Discovery Point, Wollie Creek

Discovery Point, Woll Creek Concept Plan

Building 8 Envelope Parameters

Scale	1:250 @ A1 , 1:500 @ A3		
Drawn	AW	Checked	MA
Project no.	S11191		
Status	PLANNING		
Plot Date	3/06/2013 4:49:26 PM		
Plot File	C:\Temp\masterplan-discovery-111110_Central_WAY.rvt		
Drawing no.	DA3-010	Revision	F

Building 10 Envelope Parameters

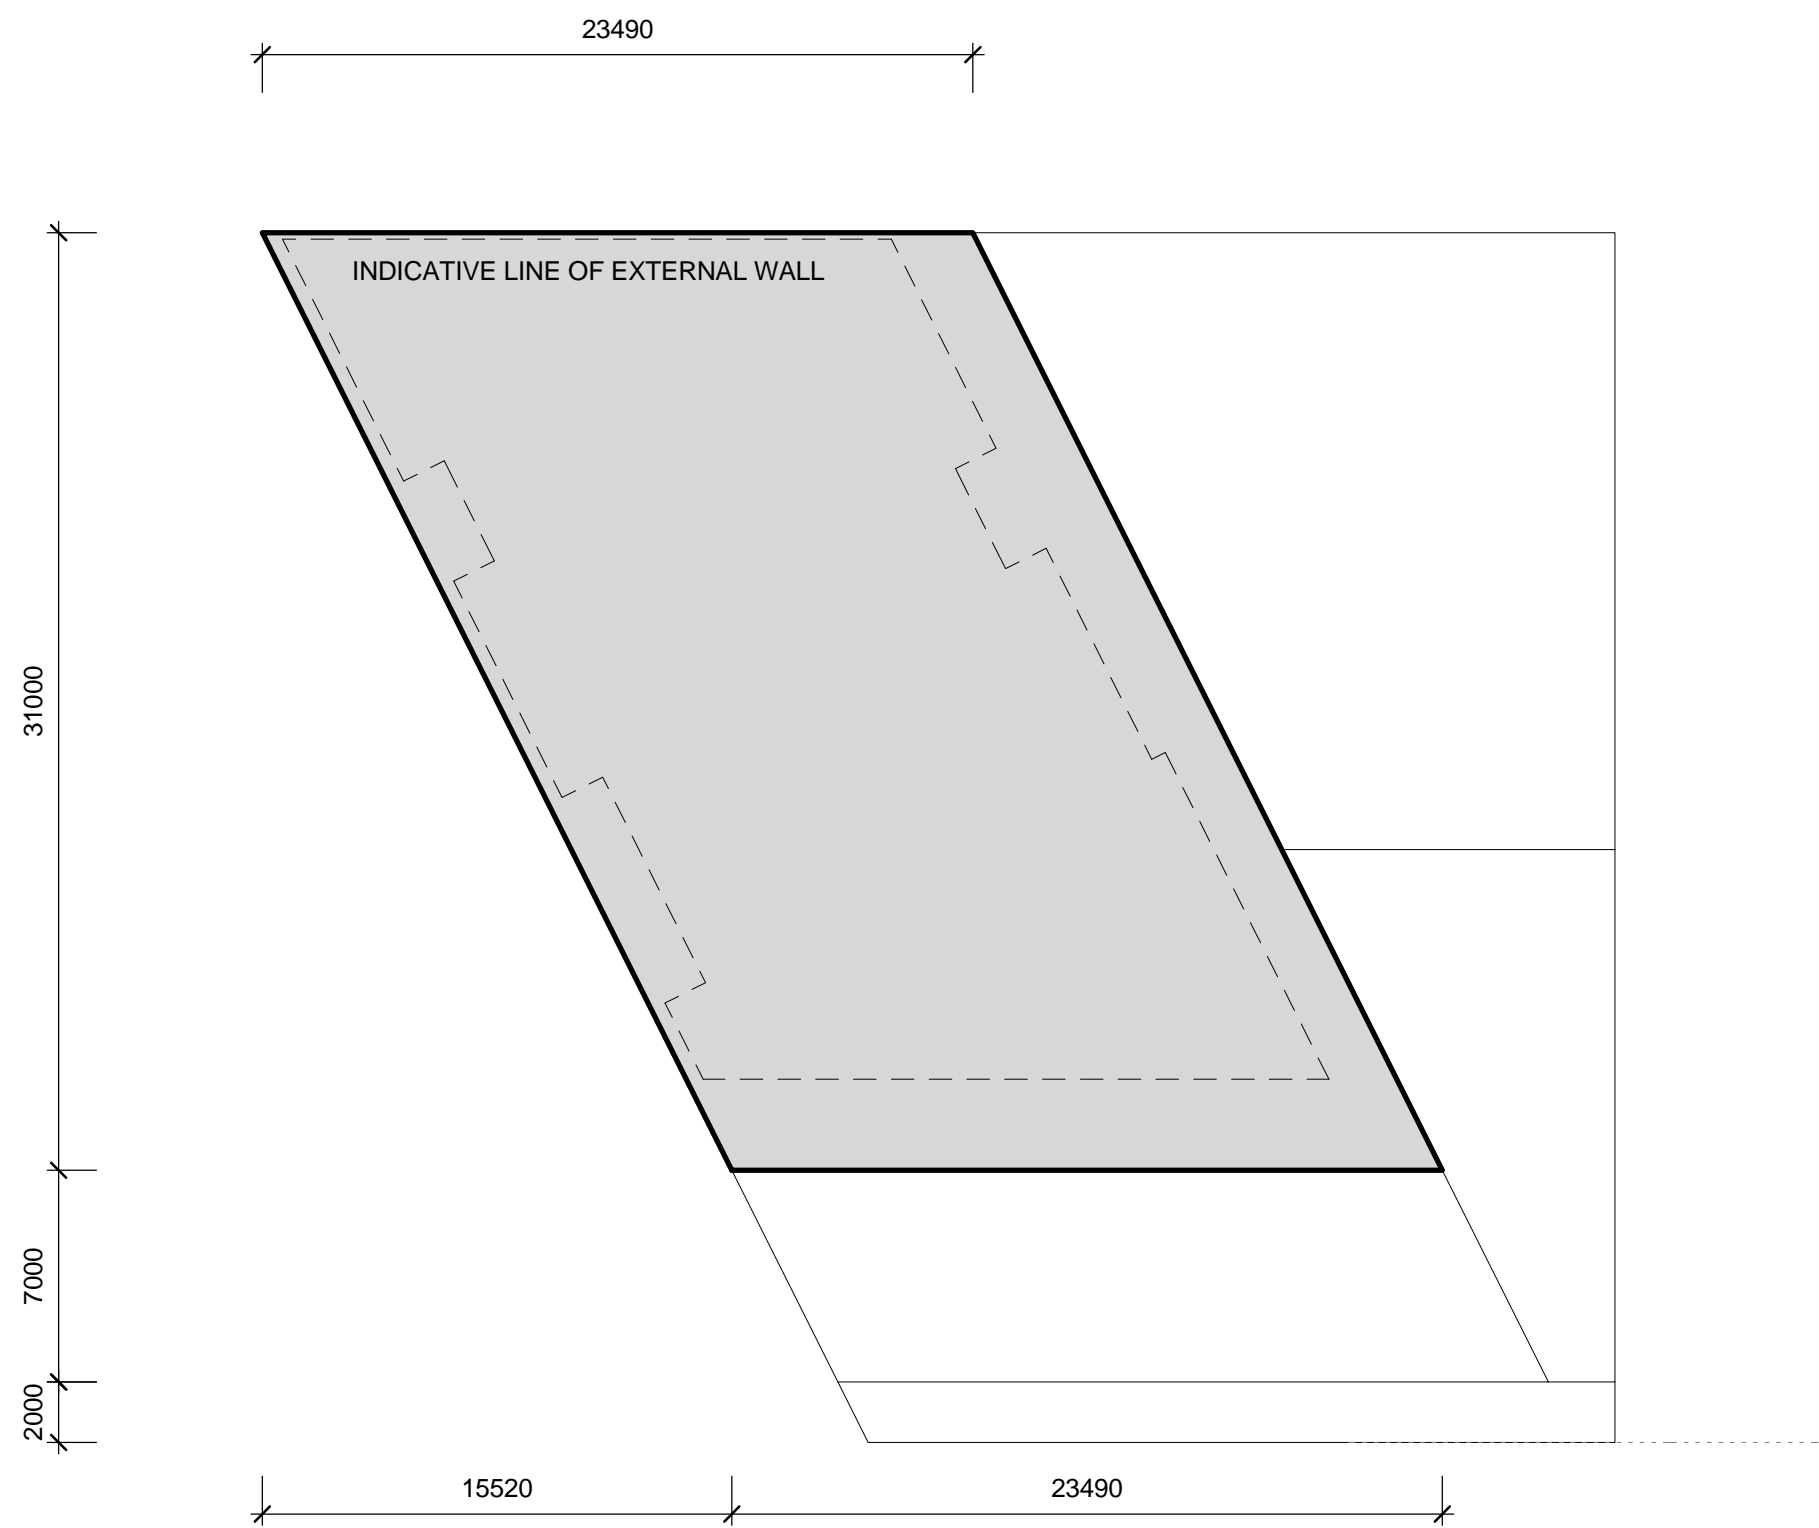
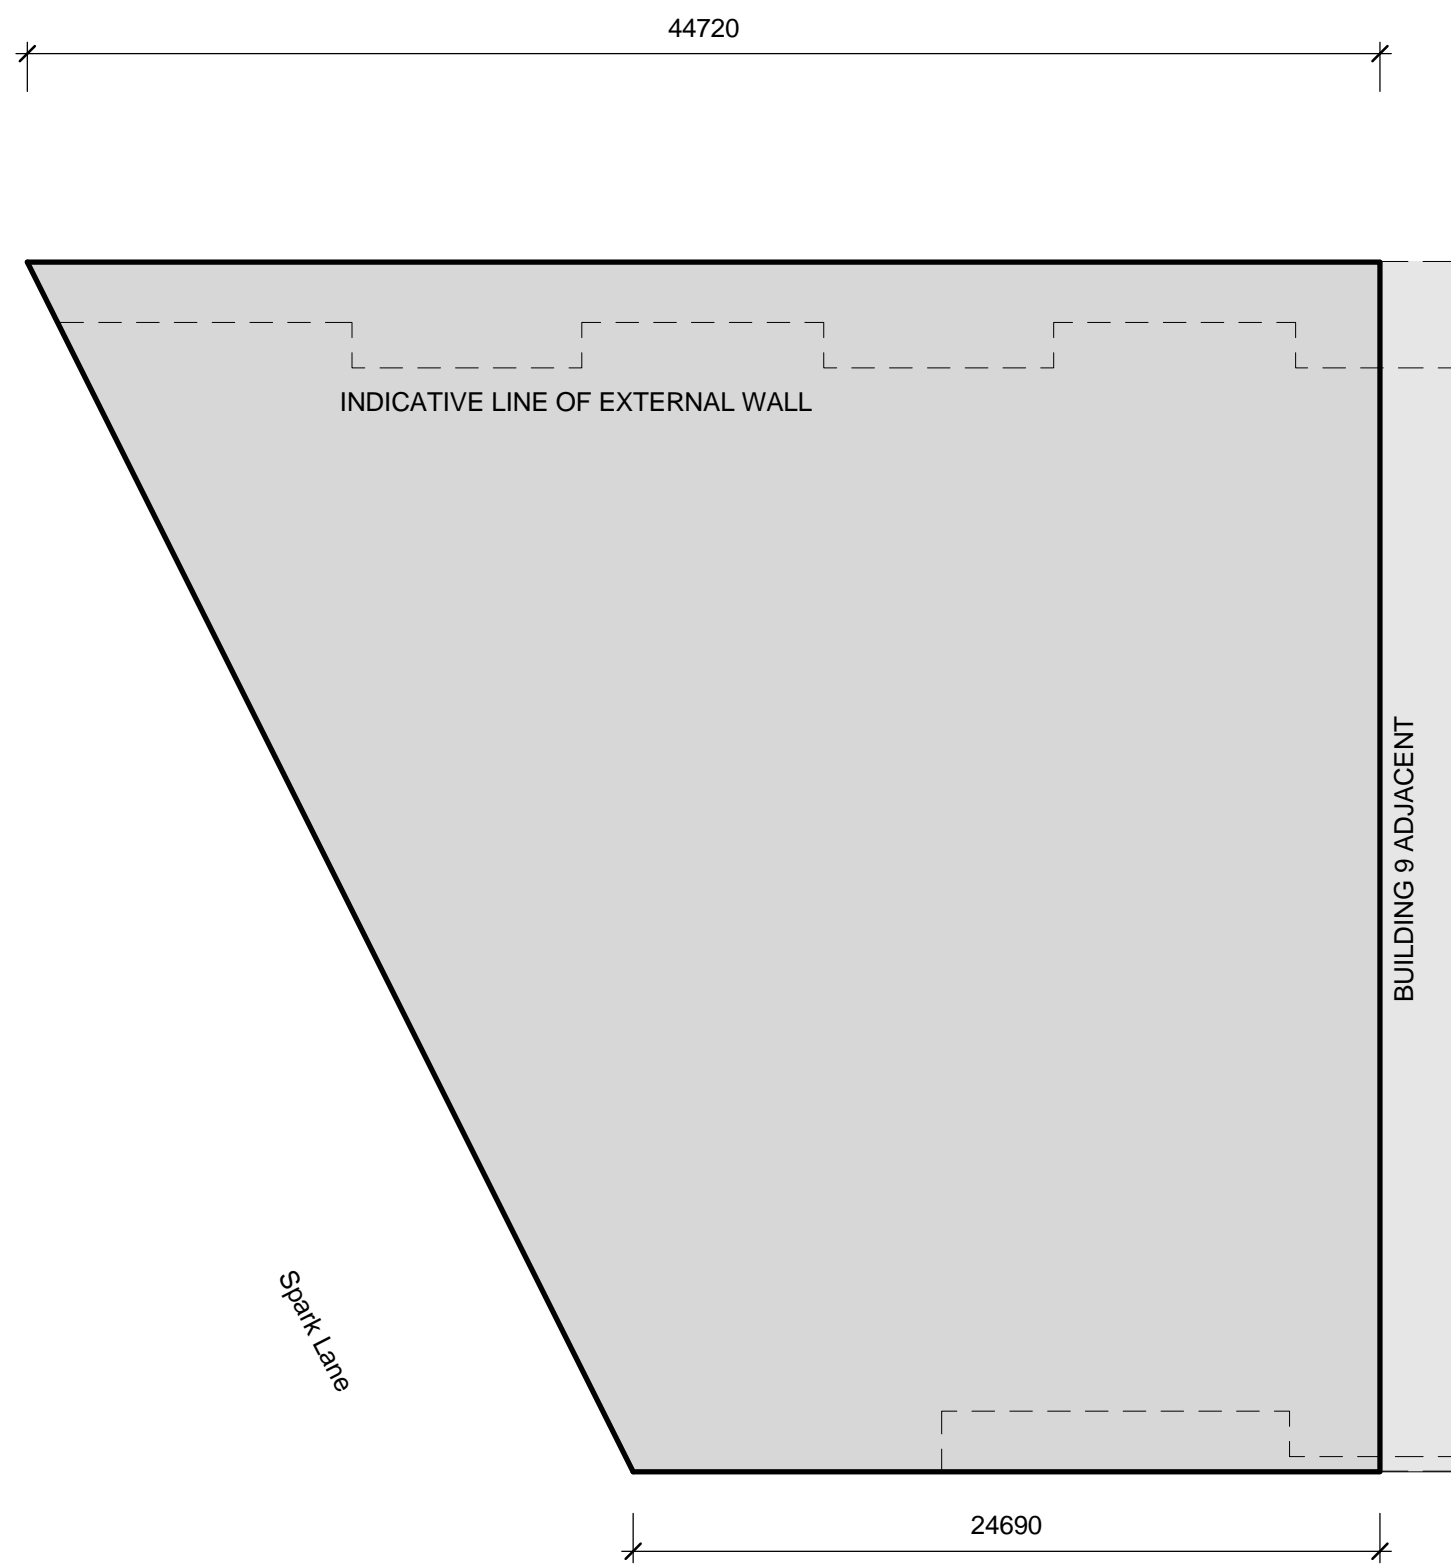
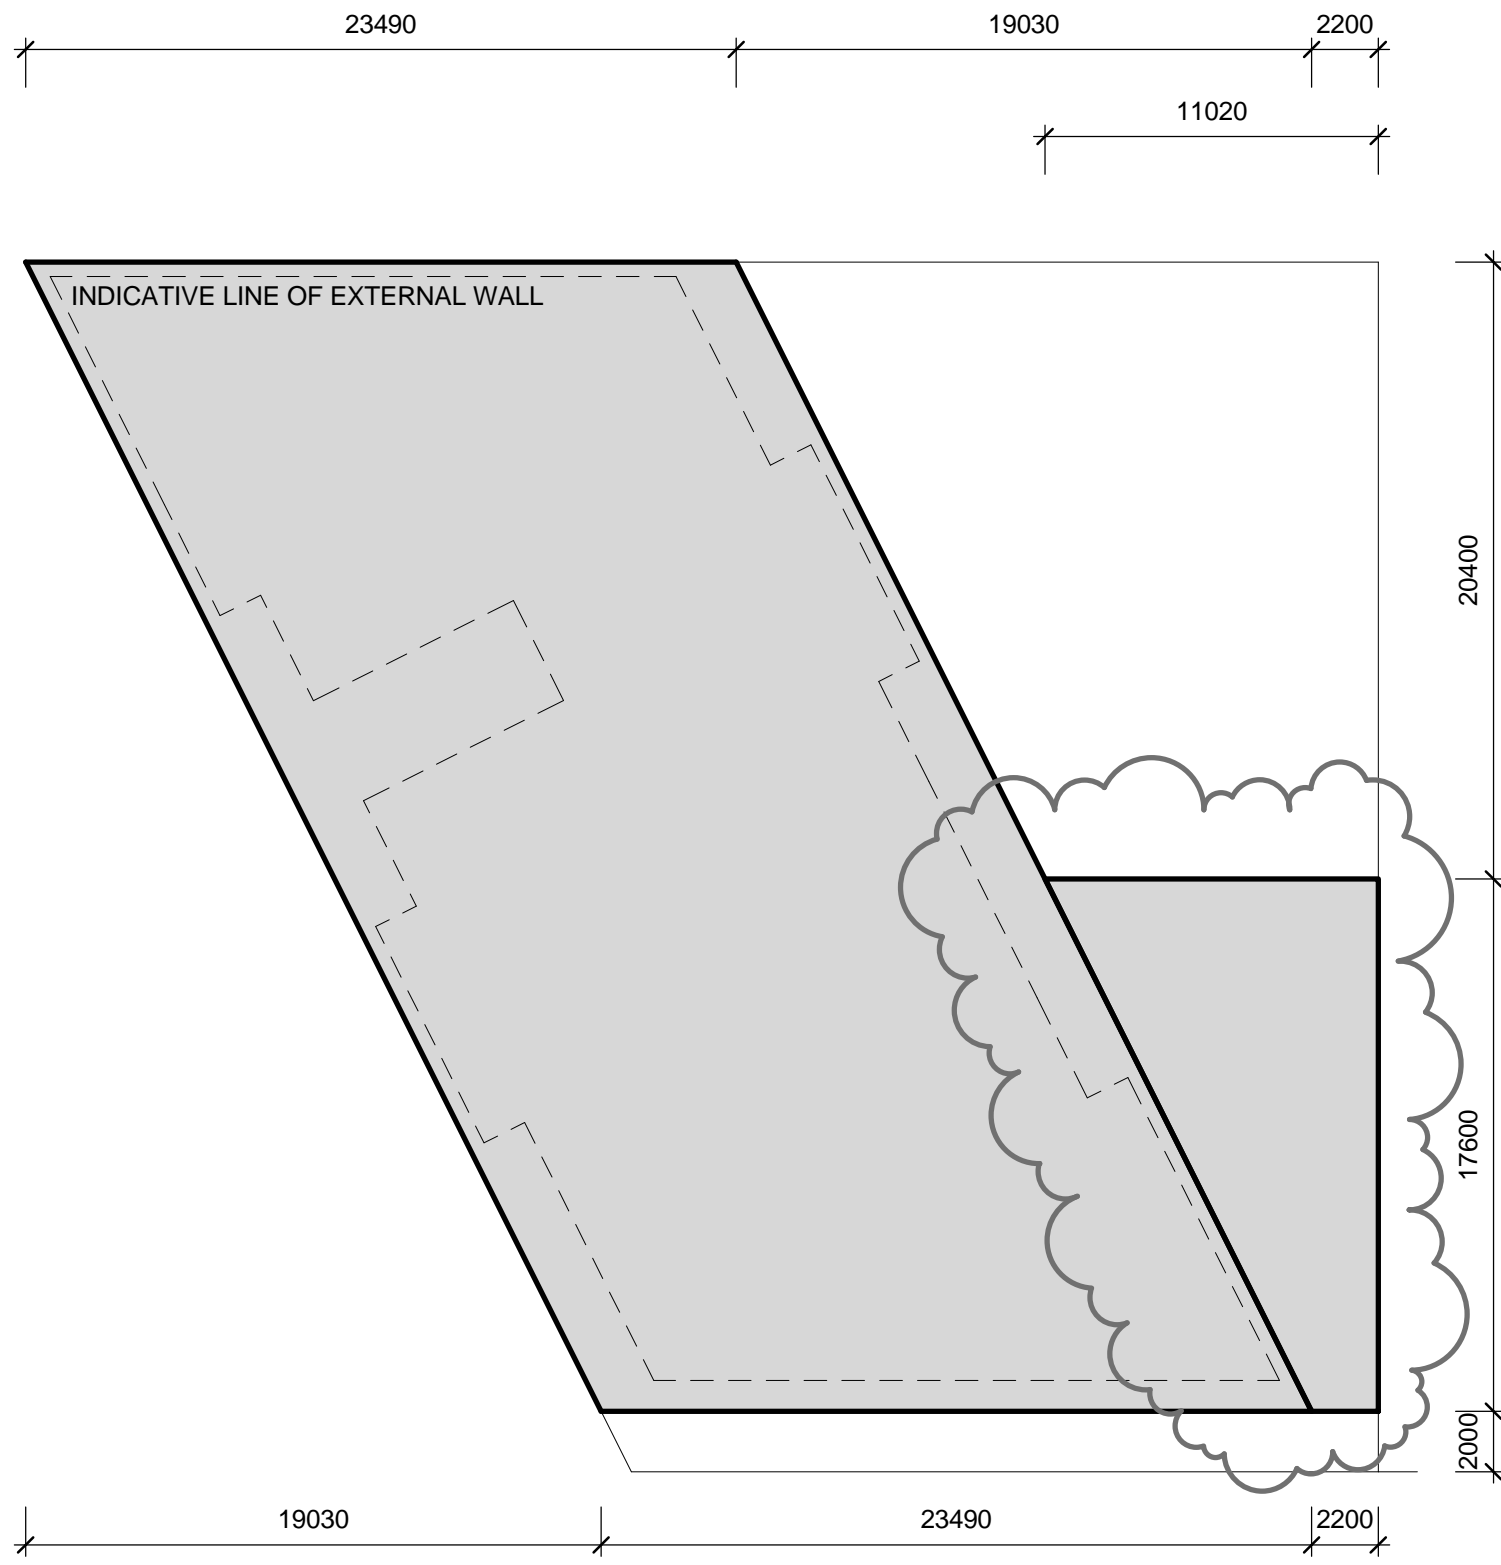
Amendments since Revision A
Envelope reduced at South and East to increase building separation
Setback to Cooks River Increased
